Raymond R. Maccary, Assistant Director for Engineering,
Division of Systems Safety

50-275

REVIEW OF PROGRESS BY DON BERNREUTER LAWRENCE LIVERMORE LABORATORIES
REGARDING SITE SPECIFIC DESIGN SPECTRA FOR THE DIABLO CANYON NUCLEAR
POWER PLANT

Figure 1. All components of all records plotted for soil and non-hard rock strong motion siesmograph sites. v/a vs a .

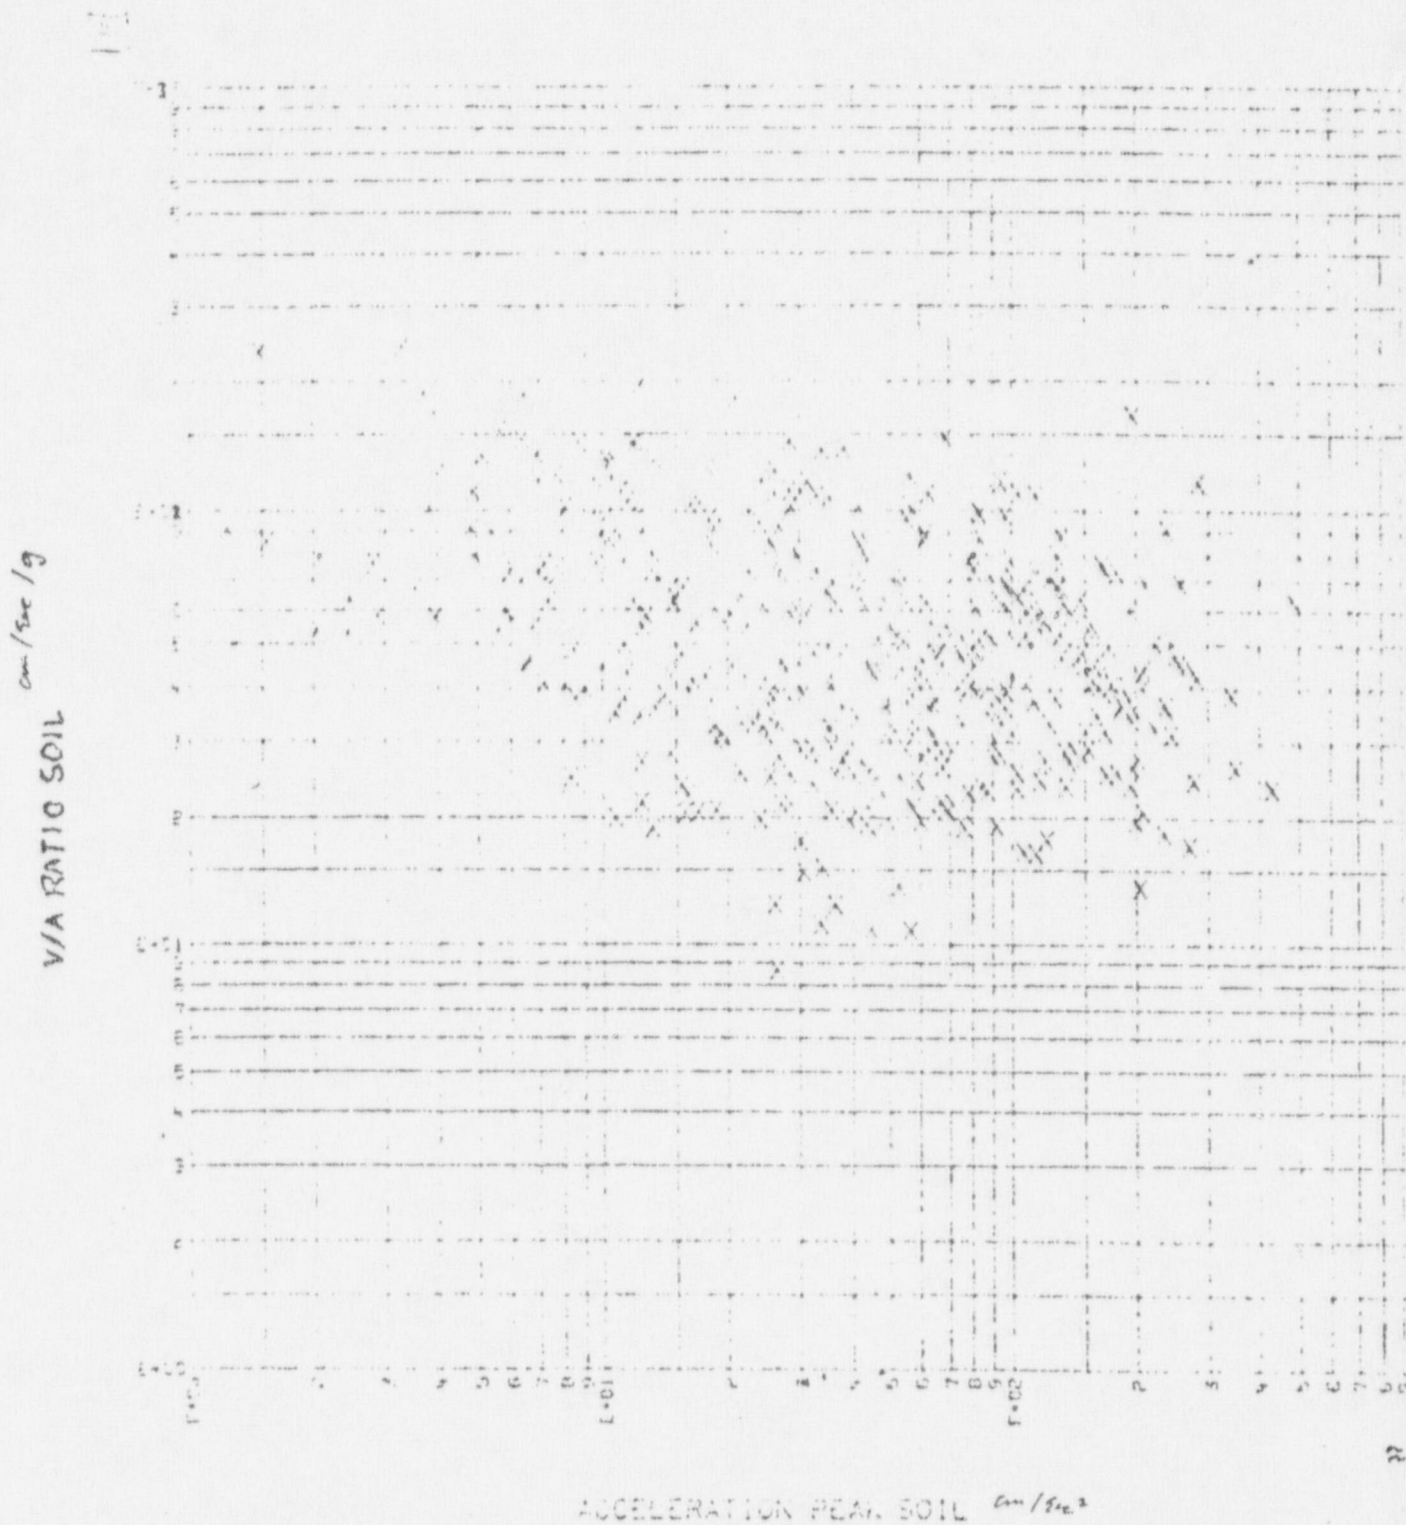
1. v/a graphs did not show a strong trend whether plotted as single component values or vector values. See for example figures 1 & 2 for soil only and rock respectively.

Figure 3. v for each component from all sites vs peak acceleration.

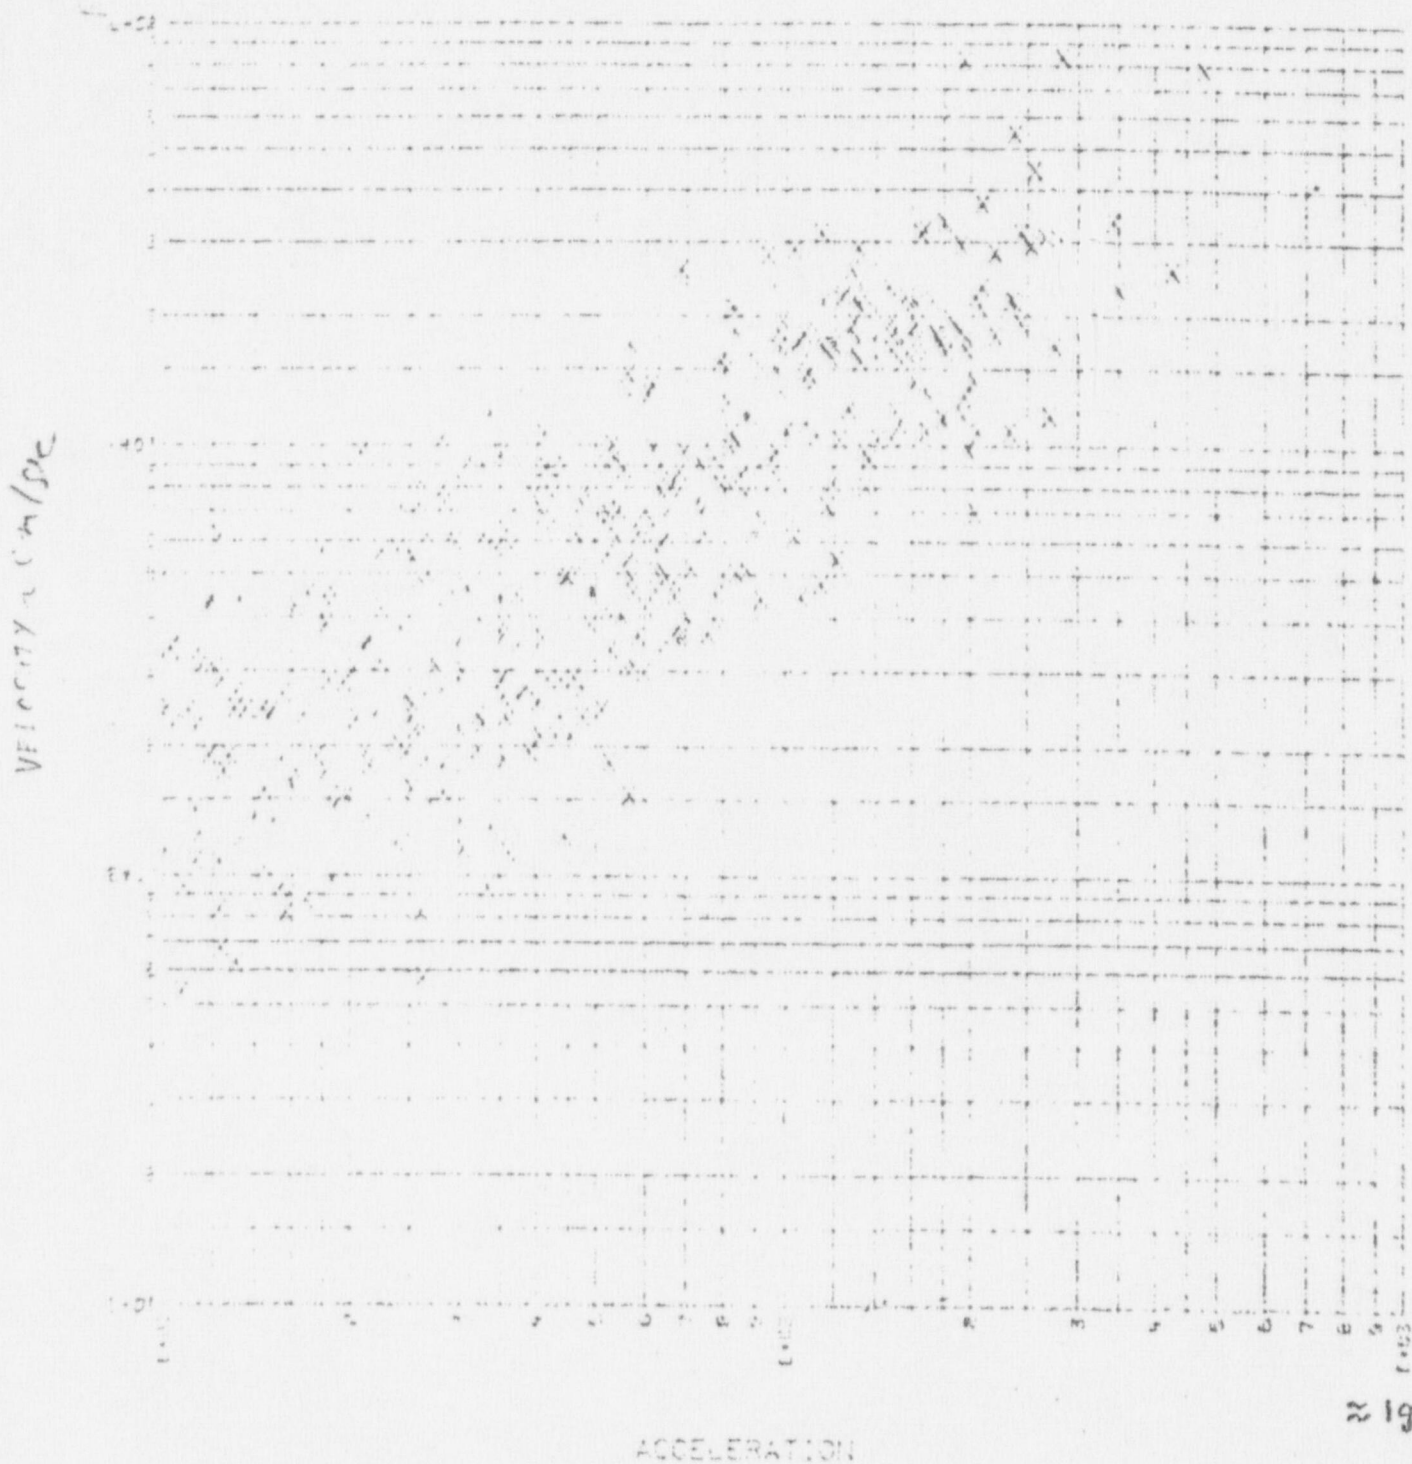
2. v vs a graphs, for example, figures 3, 4 & 5, show a trend especially where vector values are plotted. Because peak values seldom occur at the same place in the record, the vector value is assumed to better represent energy in the seismogram but the actual value on a single component is less than the vectored value. The ratio of vector values of velocity at 1g acceleration for rock and soil can be compared to determine the limiting rock velocity compared to previously determined overall limiting velocities. Tentative results are .50/.85 for vectored hard rock velocities over soil velocities, (see figures 4 & 5) or a factor of .58. This value times the previously established single component soil maximum velocity of .48 inches per second yields a possible 28 inches per second upper velocity bound for hard rock. This agrees with the value recommended by Dr. Newmark. Additional analyses and studies to clarify the nature of foundations under strong motion recording stations may modify results.

Figure 6. Ratio of main 1940 El Centro response spectra to Reg. Guide 1.60 spectra plus similar plots for smaller shocks of nearly the same epicenter (symbols O, X & Y). 5% damping.

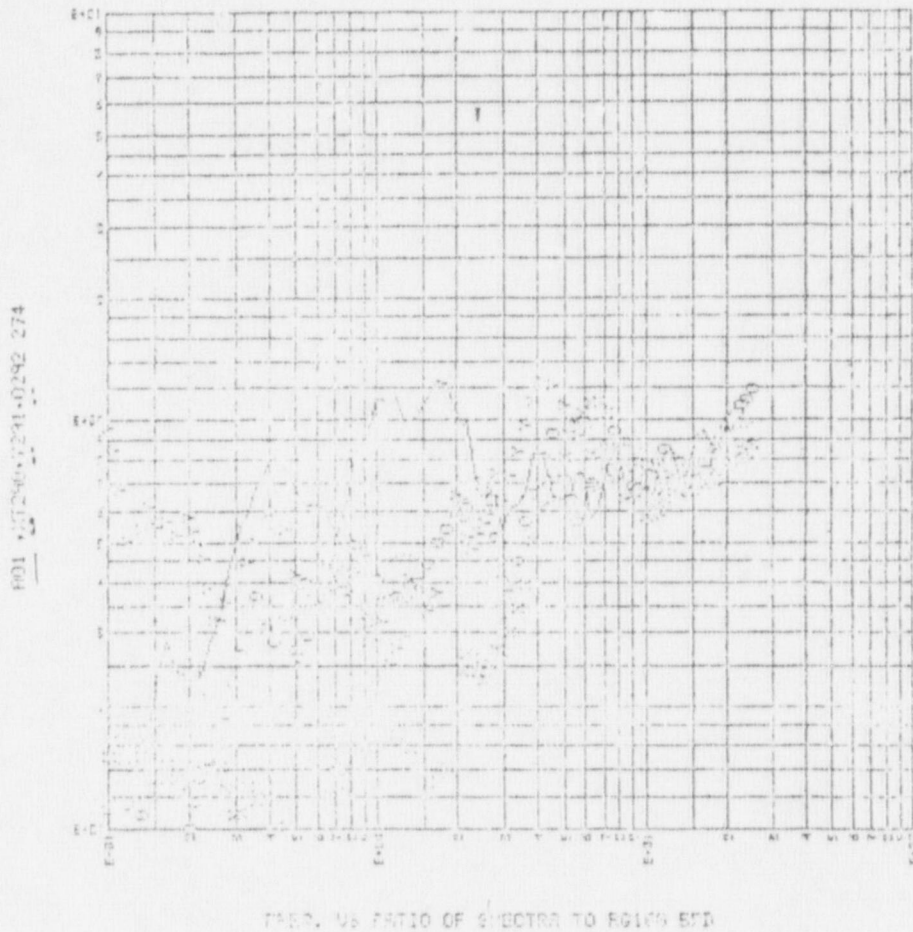
or similar epicenter and recorded at the same strong motion seismograph were prepared. Results, for example figures 6, 7 & 8, show that the relative amount of short period vibrations in small earthquakes is much larger than in large shocks. Thus scaling up the response spectra of small shocks to obtain the spectral envelope of large shocks is in error. The large earthquakes have much higher long period spectral responses components but the short period (high frequency) components increase only slightly over that for small shocks. This is an important observation. Data are few but do provide a new technical argument for not increasing high frequency spikes proportionately with magnitudes as implied by USGS Circular 672 which has been recommended as a basis for Diablo Canyon design. These data are directly from the computer with no opportunity for adequate labeling.
